BUILDING PERMIT AND INSPECTION RECORD

Municipal #: **2026047141**
Process Number: M2026007470
Issue Date:

Application Type: ALTER INTERIOR
Proposed Use: RESTAURANT-CAFETERIA
Sq. Ft.: 900 / Units: 0 / Floors: 0
Permit Type: MUNICIPAL BLDG / Permit Category: 0001 MUNICIPAL GENERAL BUILDING

PROJECT LOCATION
PINECREST BAKERY
15519 NW 67TH AVENUE
MIAMI LAKES, FLORIDA 33014

SHEET NO. P-2.0

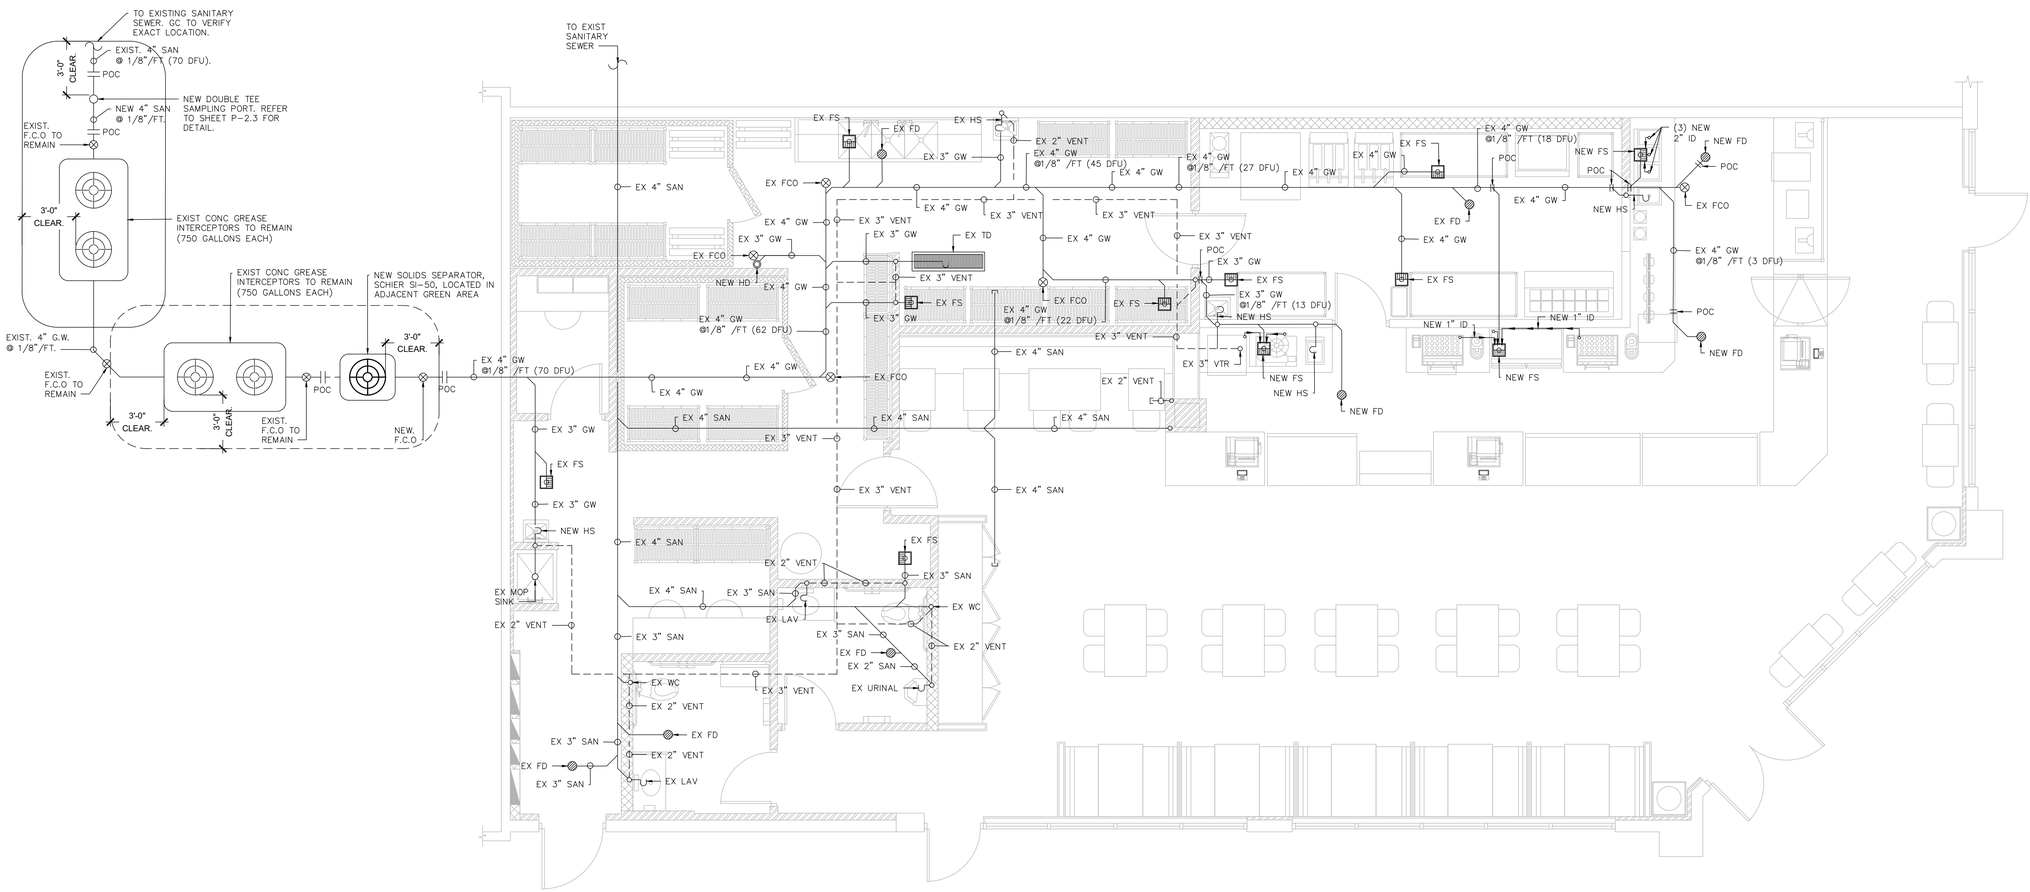
4. Specify in plans if this system is dedicated to the tenant located at 15519 NW 67 Ave. **Please refer to revised sheets P-2.0 and P-2.2.**
